SARA referral agency response—1018 - 1038 Yaamba Road, Parkhurst

Description:	Development permit	Material change of use for a service station
		Reconfiguring a lot (one lot into two lots)
		Operational work for advertising

Decision Notice – Permitted Road Access Location (s62(1) *Transport Infrastructure Act 1994*)

Drawing Title		Job Number - Drawing Number		Revision
DEVELOPMENT SITE PLAN		22175	DA01	E

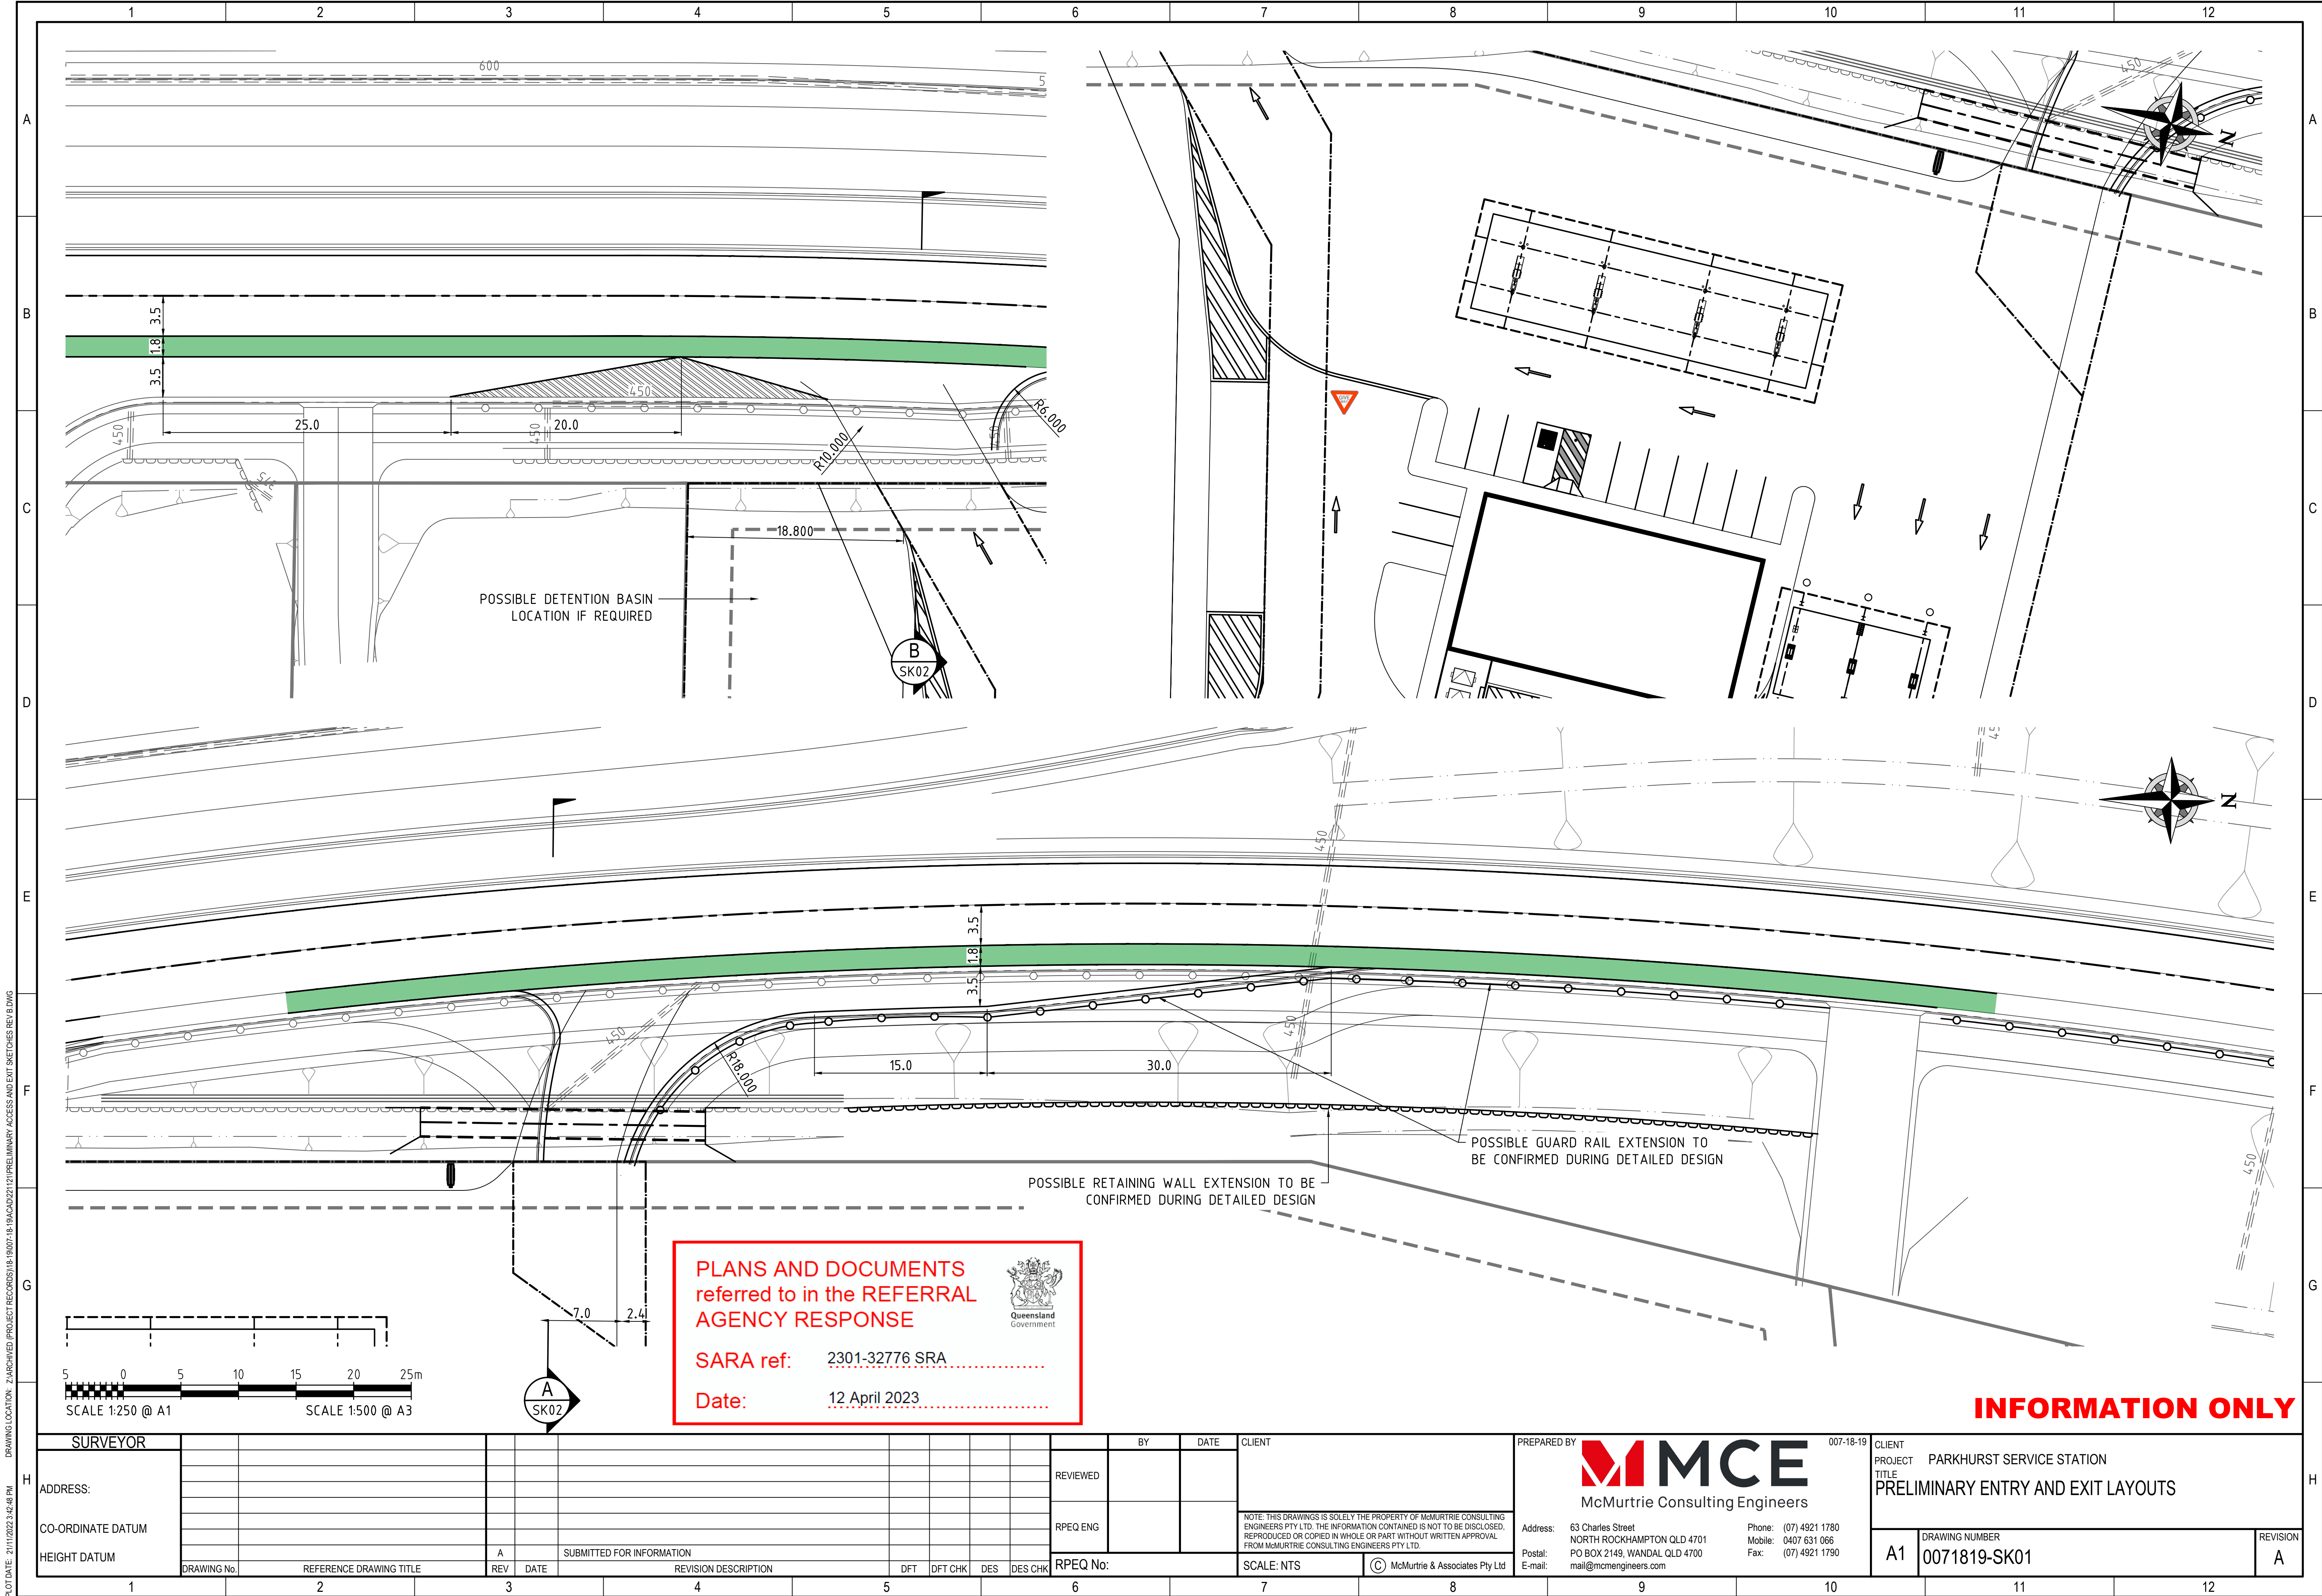
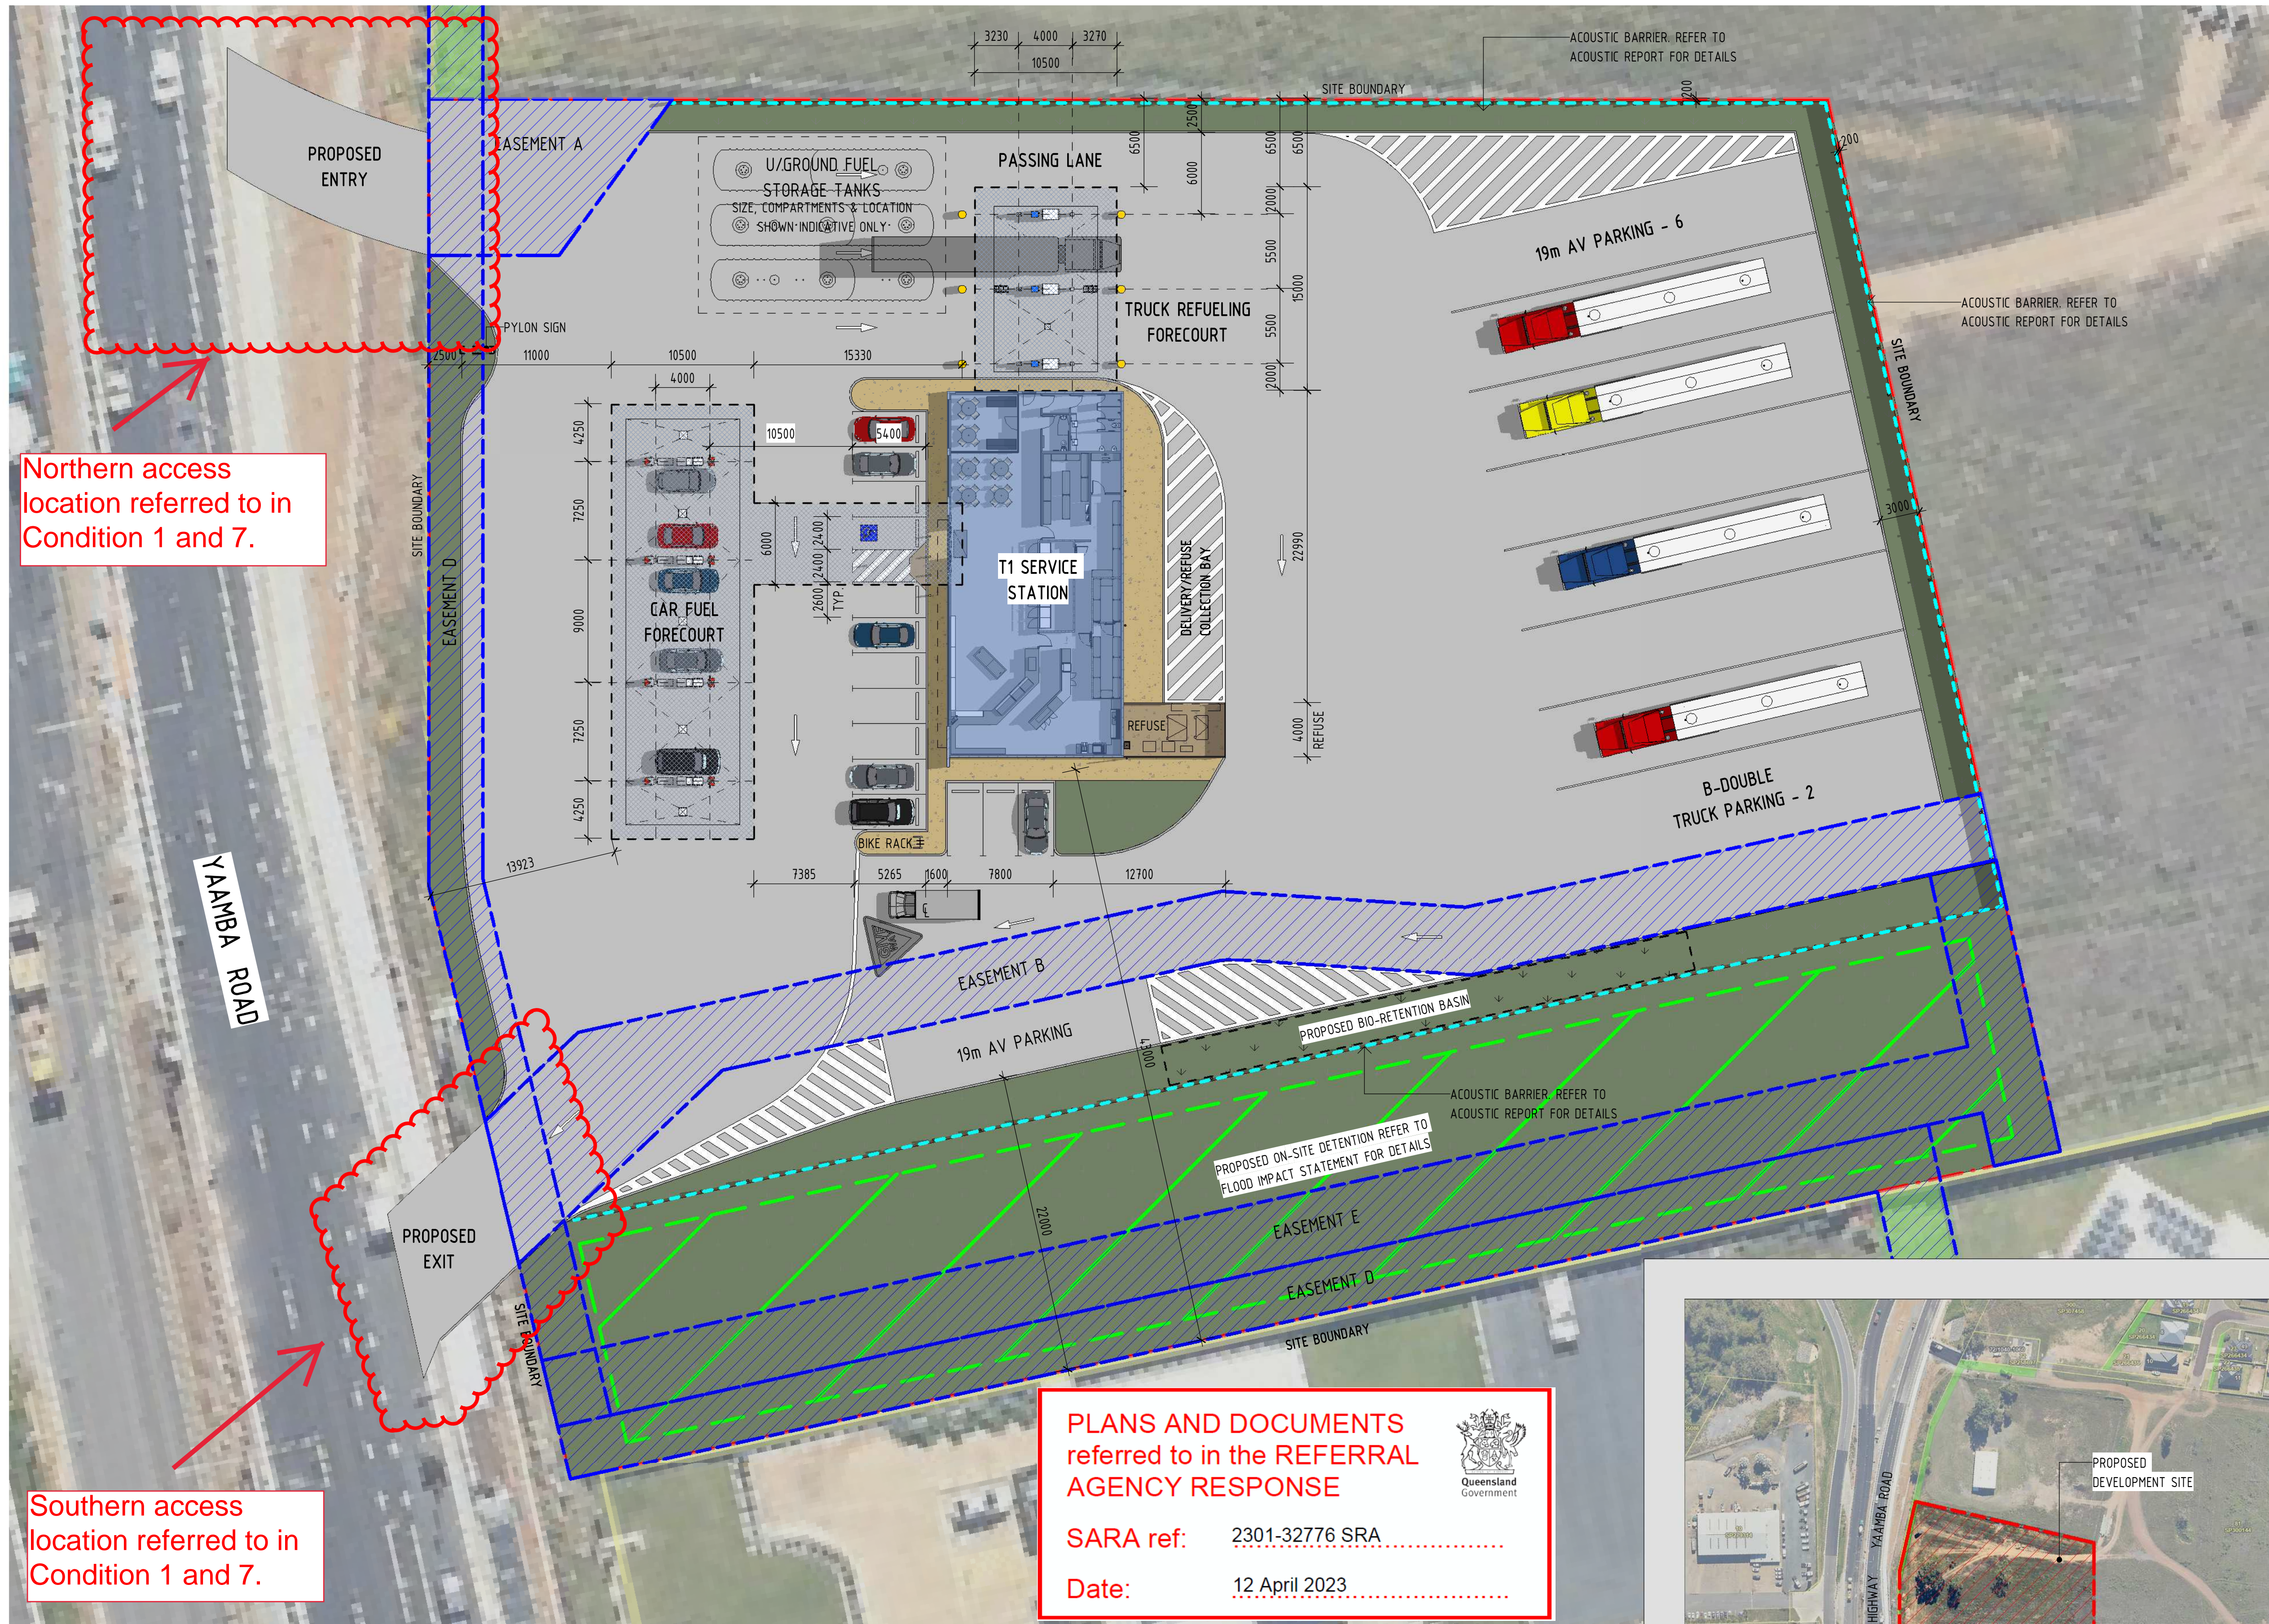
1.	The northern and southern road access locations are to be located generally in accordance with the DEVELOPMENT SITE PLAN, prepared by Verve Building Design Co, dated 14.03.2023, reference 22175, revision E, as amended in red by SARA.	At all times.

7.	The northern and southern road access locations are to be located generally in accordance with the DEVELOPMENT SITE PLAN, prepared by Verve Building Design Co, dated 14.03.2023, reference 22175, revision E, as amended in red by SARA.	At all times.

Amended in red by SARA on
12 April 2023

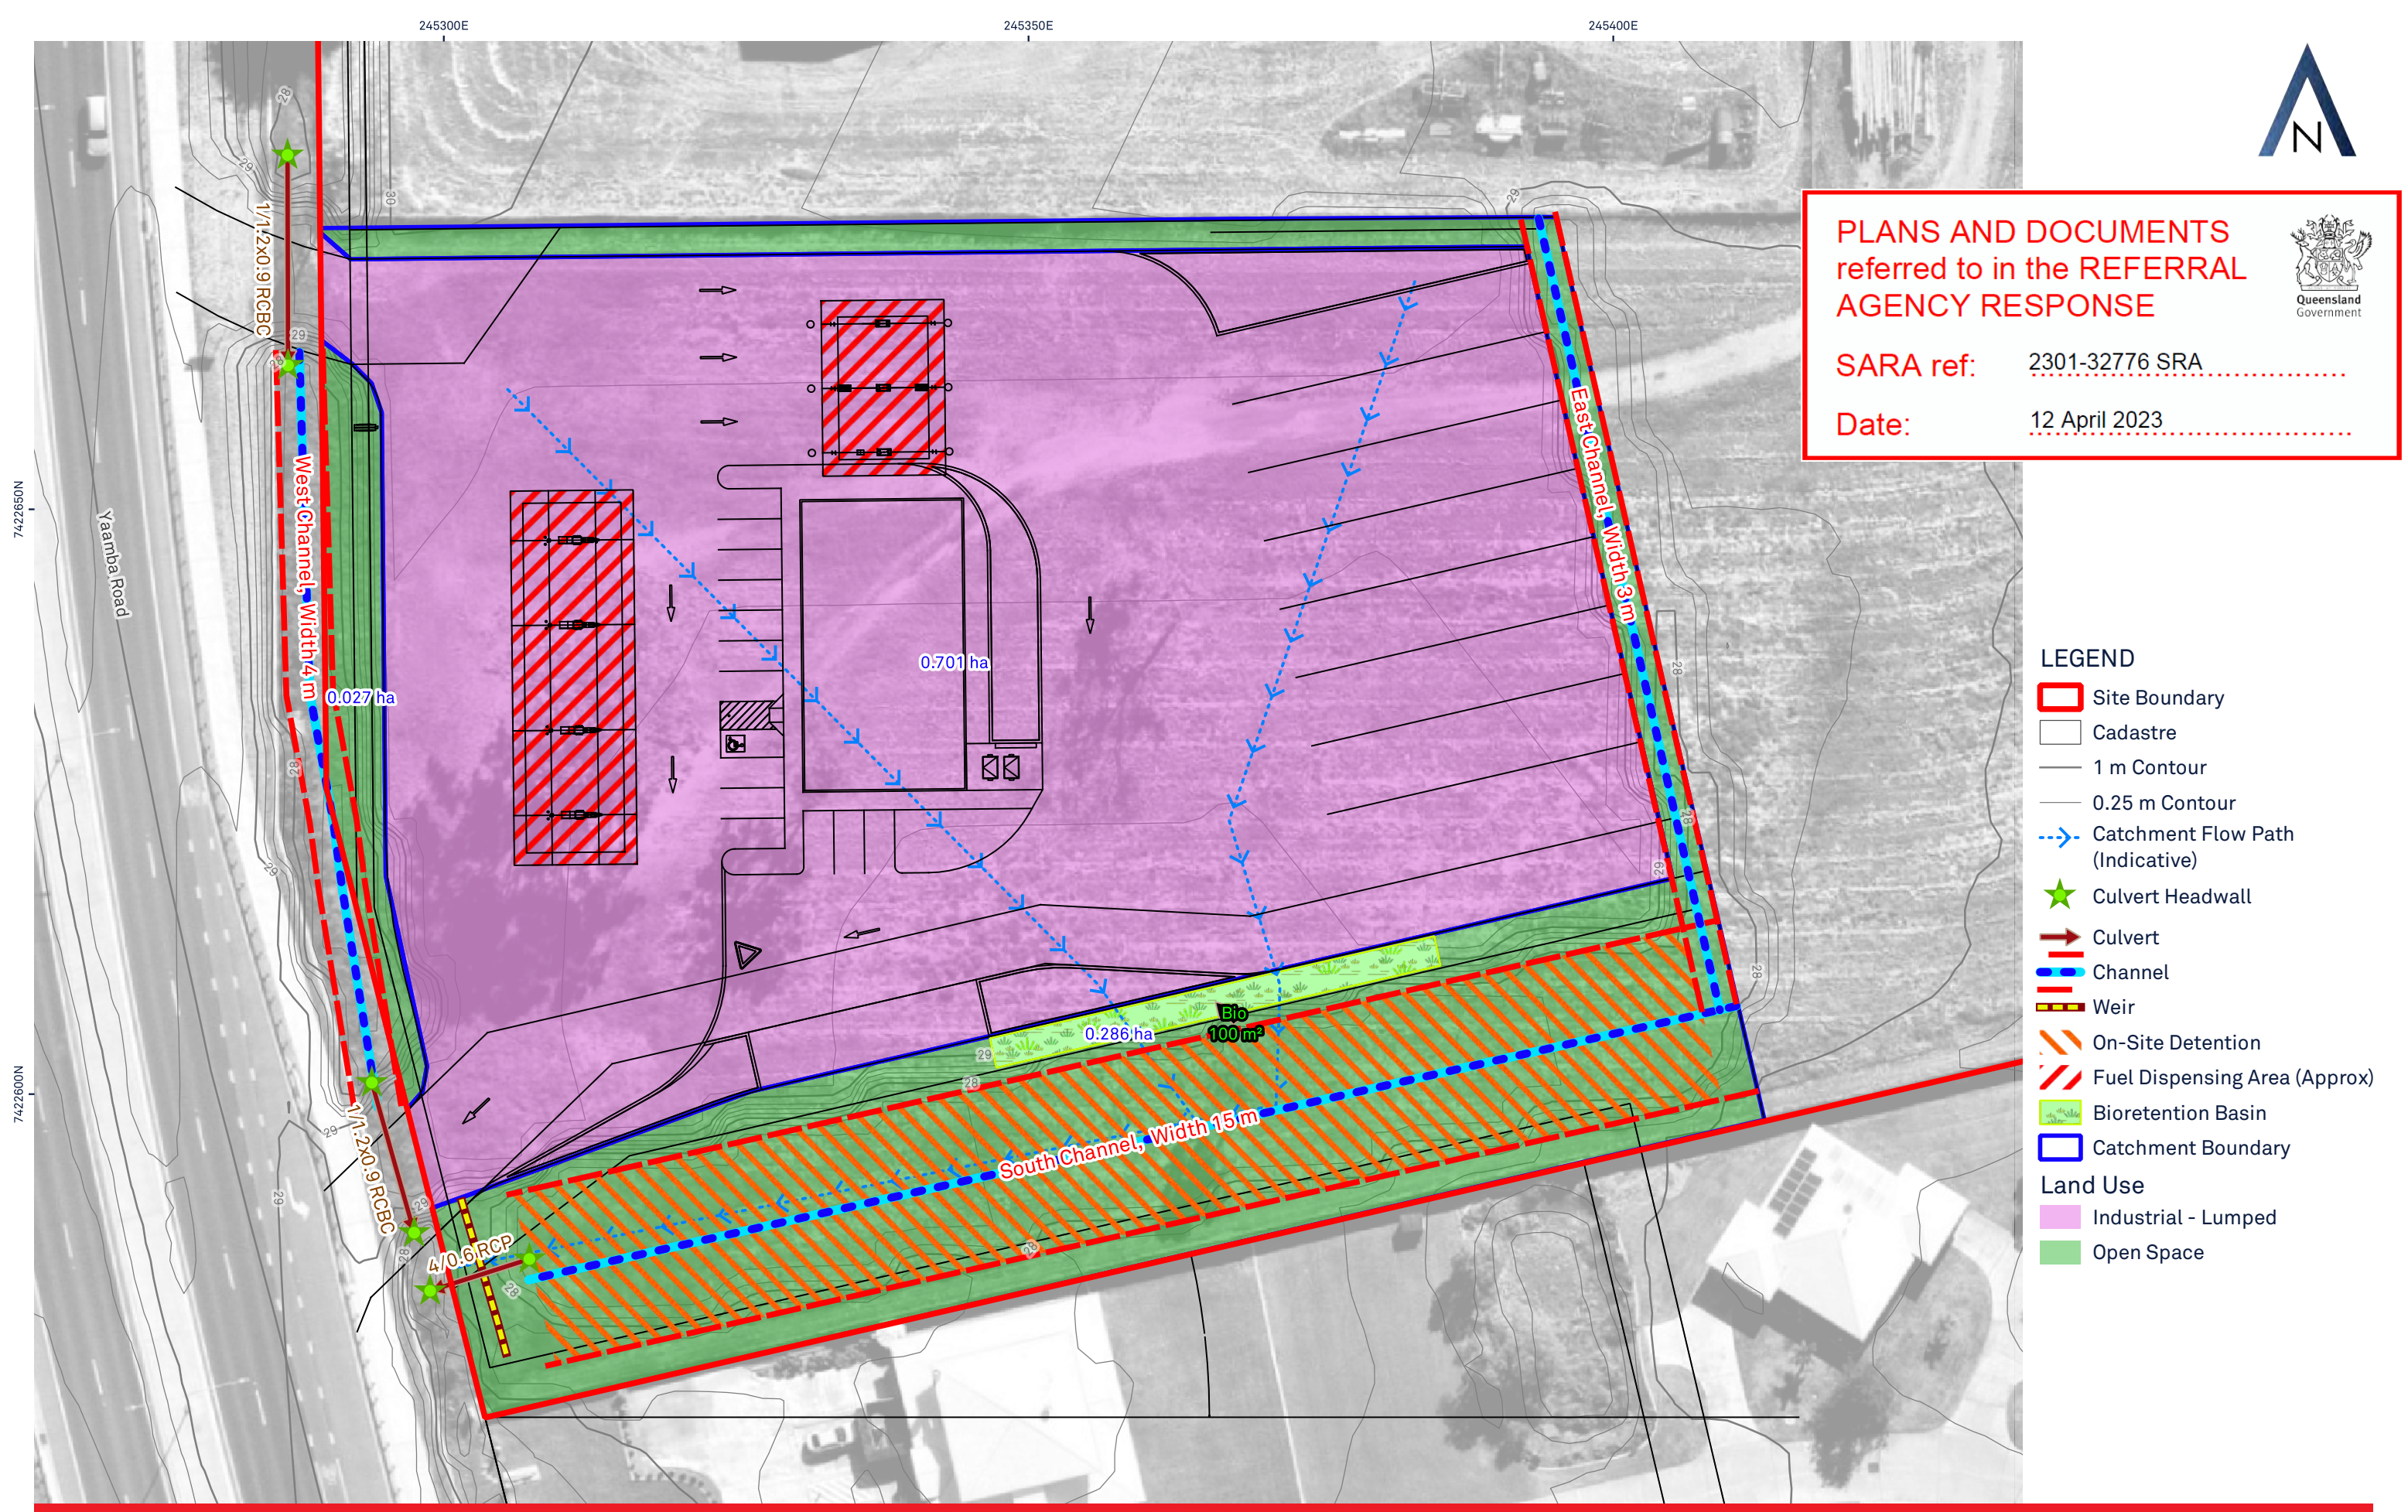
the permitted road access locations stated in Condition 1.	
6.	Carry out stormwater management of the development generally in accordance with sections 2.3, 3.1, 3.2, and Figure 6 of the Flood Impact Assessment & Stormwater Management Plan, prepared by McMurtrie Consulting Engineers, dated 6 March 2023, reference J200037, no revision, as amended in red by SARA.	At all times.
Reconfiguring a Lot
